**BROWNS FERRY NUCLEAR PLANT (BFN) - UNITS 1, 2, AND 3 -
TECHNICAL SPECIFICATIONS (TS) CHANGES TS-431 AND TS-418 -
EXTENDED POWER UPRATE (EPU) - RESPONSE TO ROUND 5 REQUEST FOR
ADDITIONAL INFORMATION (TAC NOS. MC3812, MC3743, AND MC3744)**

TECHNICAL SPECIFICATIONS (TS) CHANGES TS-431 AND TS-418 -
EXTENDED POWER UPRATE (EPU) - RESPONSE TO ROUND 5 REQUEST FOR
ADDITIONAL INFORMATION (TAC NOS. MC3812, MC3743, AND MC3744)

This enclosure provides TVA's response to the NRC staff's June 2, 2006, Round 5 Request for Additional Information (ADAMS Accession No. ML061460137).

Figure EEEB.10-1: Drywell Temperature Profiles

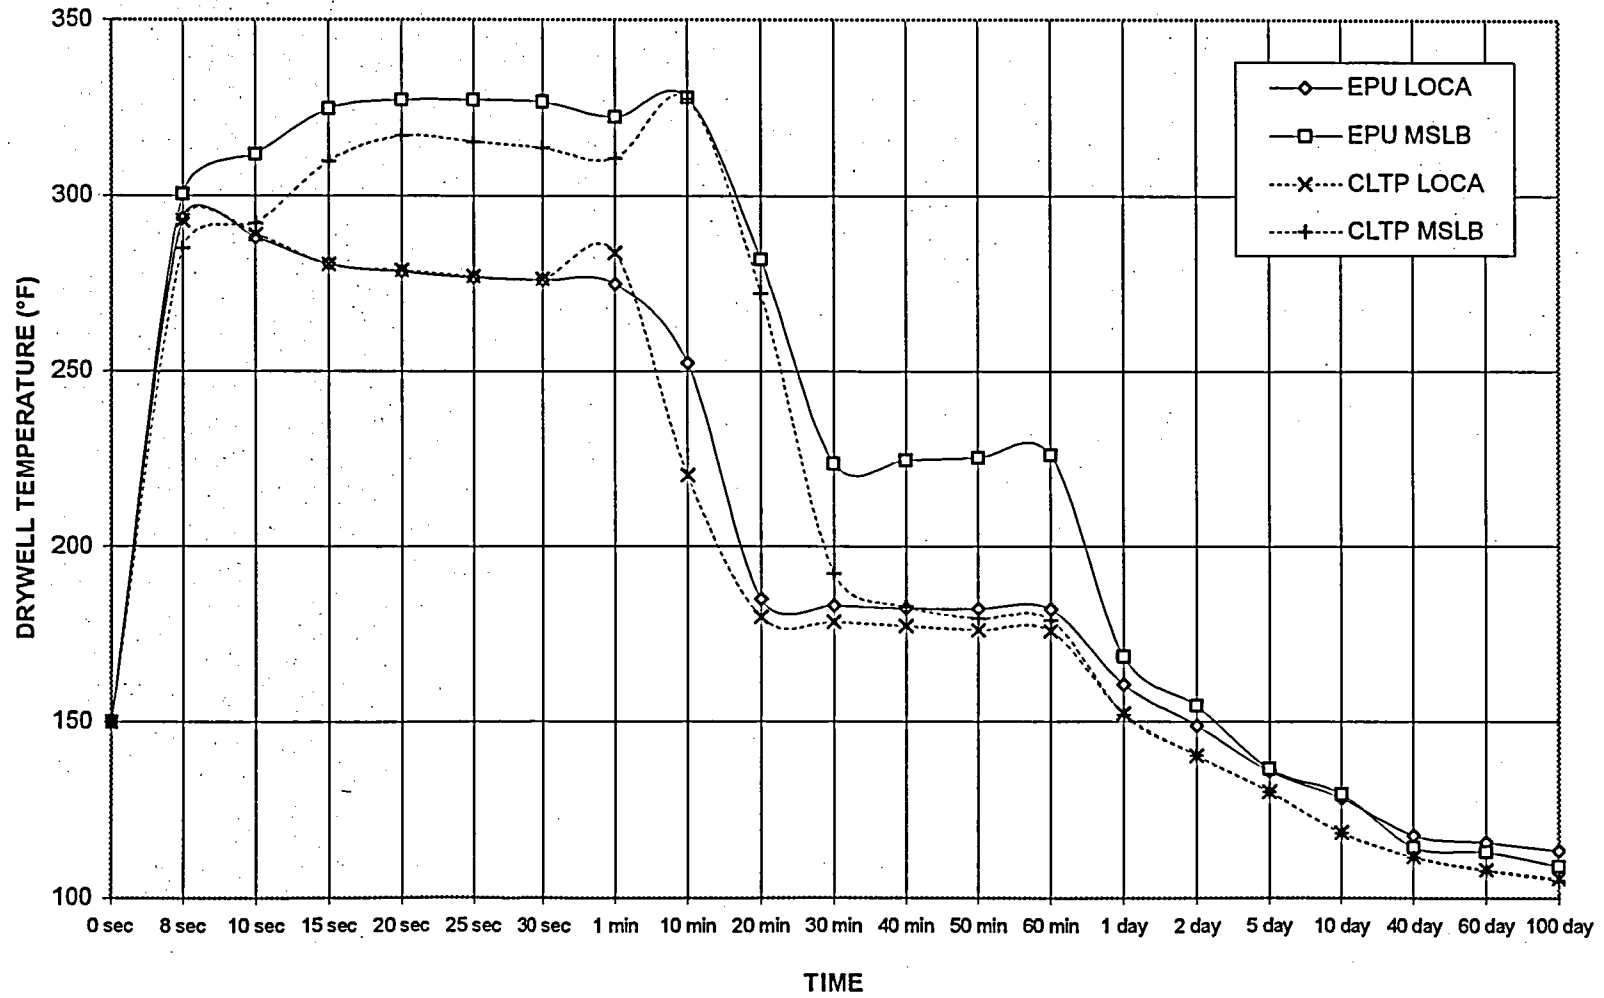
In Section 10.3.1.1 of NEDC-33101P regarding Environmental Qualification (EQ), it is stated that 1) normal temperatures are expected to increase slightly, but remain bounded by normal temperatures used in the EQ analysis, 2) the post-accident peak temperature and pressure do not significantly increase for EPU, and 3) the long-term post-accident temperatures inside containment increase, however the increase was determined not to adversely effect the qualification of safety-related electrical equipment. Specify the temperature and pressure before and after EPU and demonstrate that the increase is within the design margin of qualification of the electrical equipment.

3) NEDC-33101P states that the long-term post-accident temperatures inside containment increase. However, the increase in long-term post-accident temperatures was determined not to adversely affect the qualification of safety-related electrical equipment. For BFN EQ analyses, the EQ evaluations consider the temperature versus time profiles based on MSLB and/or DBA-LOCA conditions. For EPU conditions the post-accident temperature profiles are greater than the CLTP temperature profiles. Figures EEEB.10-1 and EEEB.10-2 are provided to show the comparison of drywell and wetwell temperature profiles for CLTP and EPU conditions.

For the EQ of equipment located inside containment, the EPU long-term temperature profiles based on MSLB/DBA-LOCA conditions were compared to the EQ test profiles for the specific equipment to ensure that the EPU conditions are enveloped by the test conditions. In cases where the test conditions do not completely envelop the EPU conditions, the long-term temperatures were further evaluated using the RCM Technologies System 1000 computer program (Arrhenius calculation) to demonstrate that the EPU conditions were within the qualification requirements for the affected equipment.
